AGENDA – Planning Commission Meeting - Amended

Farley Property General Plan Amendment, Rezone, Concept Plan

Exhibit 2: (First Concept Plan with redlines)

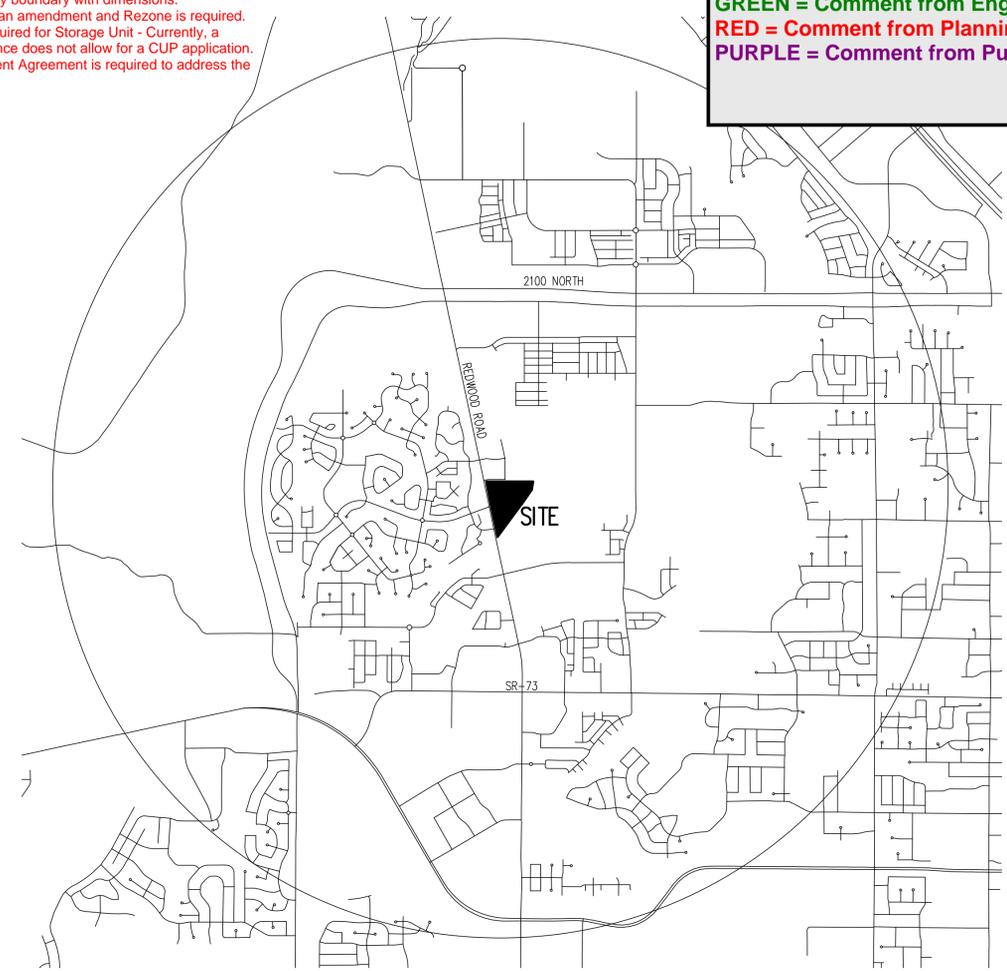
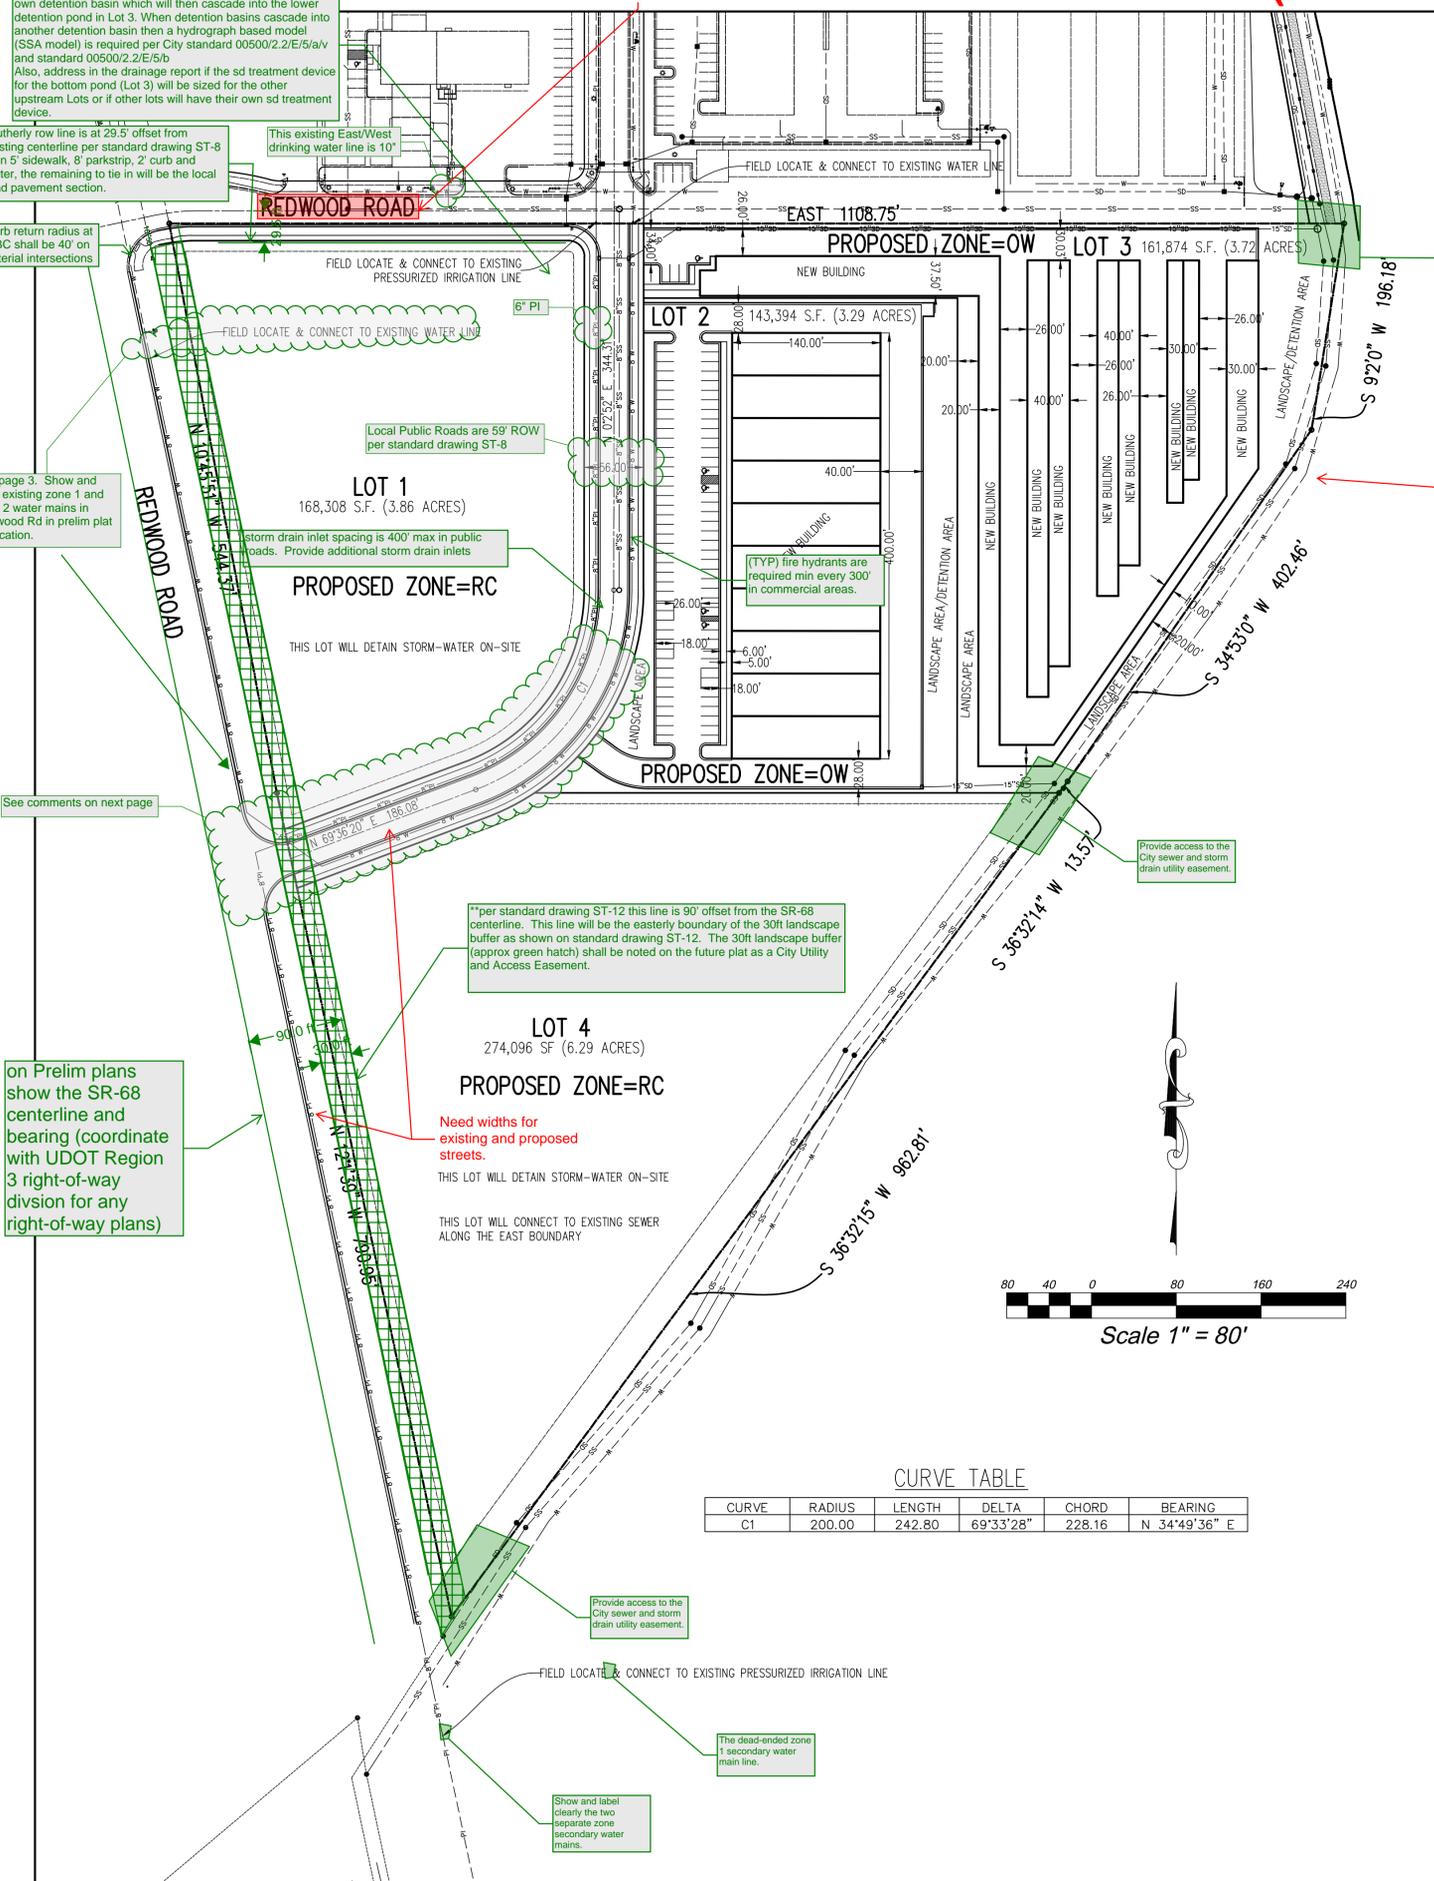
(TYP) We suggest 1 regional pond instead of a pond per lot. It appears from the concept plan that Lot 1 will have its own detention basin which will then cascade into the lower detention pond in Lot 3. When detention basins cascade into another detention basin then a hydrograph based model (SSA model) is required per City standard 00500/2.2/E/5/a/v and standard 00500/2.2/E/5/b. Also, address in the drainage report if the sd treatment device for the bottom pond (Lot 3) will be sized for the other upstream Lots or if other lots will have their own sd treatment device.

southerly row line is at 29.5' offset from existing centerline per standard drawing ST-8 then 5' sidewalk, 8' parkstrip, 2' curb and gutter, the remaining to tie in will be the local road pavement section.

curb return radius at TBC shall be 40' on arterial intersections

See page 3. Show and label existing zone 1 and zone 2 water mains in Redwood Rd in prelim plat application.

Change the name of this proposed street.

*per standard drawing ST-12 this line is 90' offset from the SR-68 centerline. This line will be the easterly boundary of the 30ft landscape buffer as shown on standard drawing ST-12. The 30ft landscape buffer (approx green hatch) shall be noted on the future plat as a City Utility and Access Easement.

Scale: 1"=80'
 Date: 12/17/19
 C1

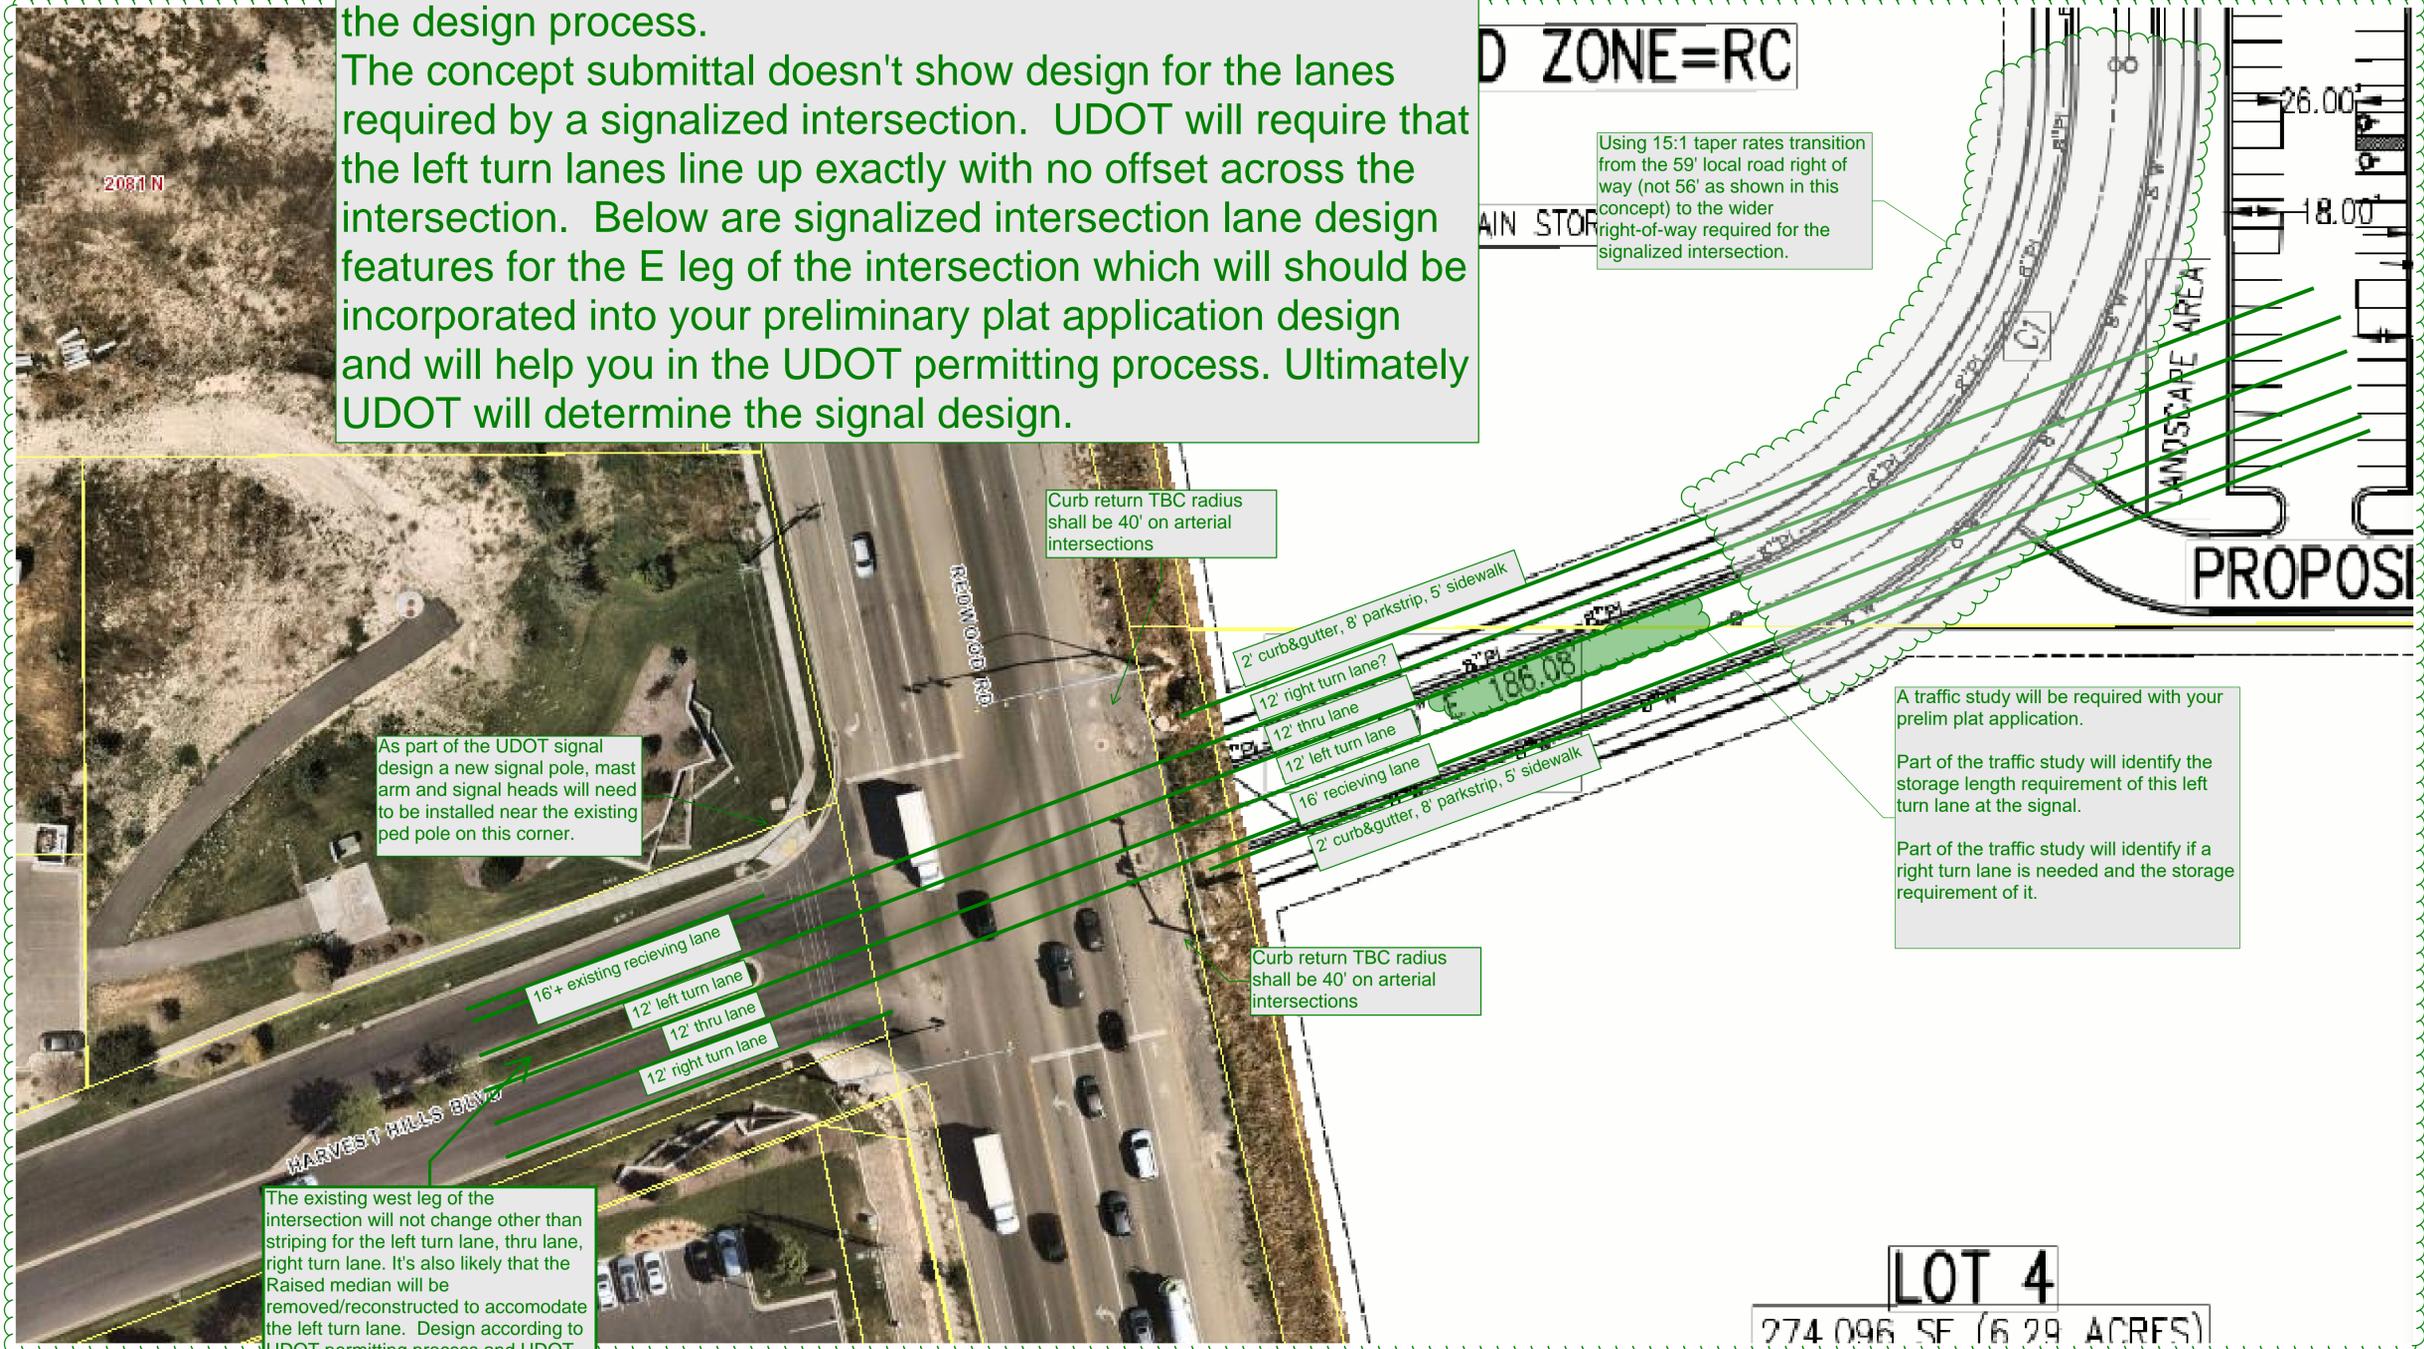
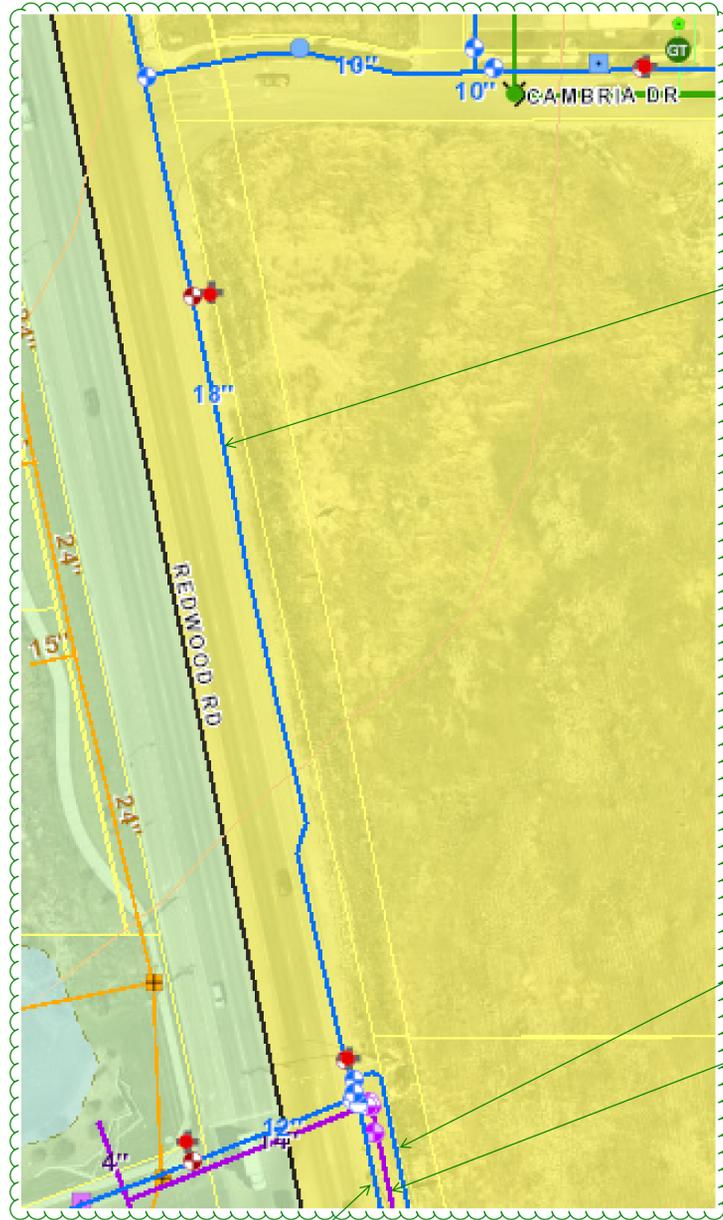
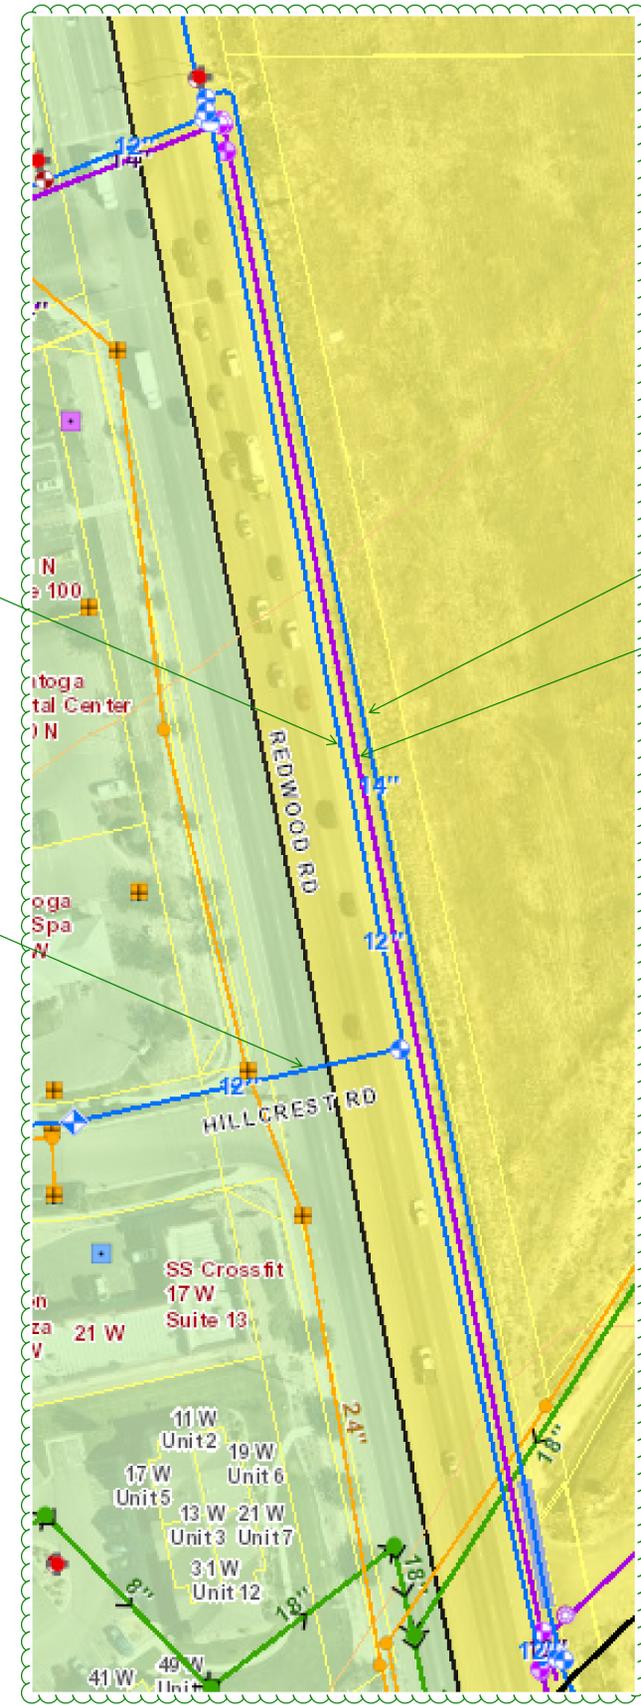
Using 15:1 taper rates transition from the 59' local road right of way (not 56' as shown in this concept) to the wider right-of-way required for the signaled intersection.

A traffic study will be required with your prelim plat application. Part of the traffic study will identify the storage length requirement of this left turn lane at the signal. Part of the traffic study will identify if a right turn lane is needed and the storage requirement of it.

existing 18" zone 1 drinking water

existing 14" zone 1 drinking water

existing 14" zone 2 secondary water

existing 12" zone 2 drinking water

existing 14" zone 1 drinking water
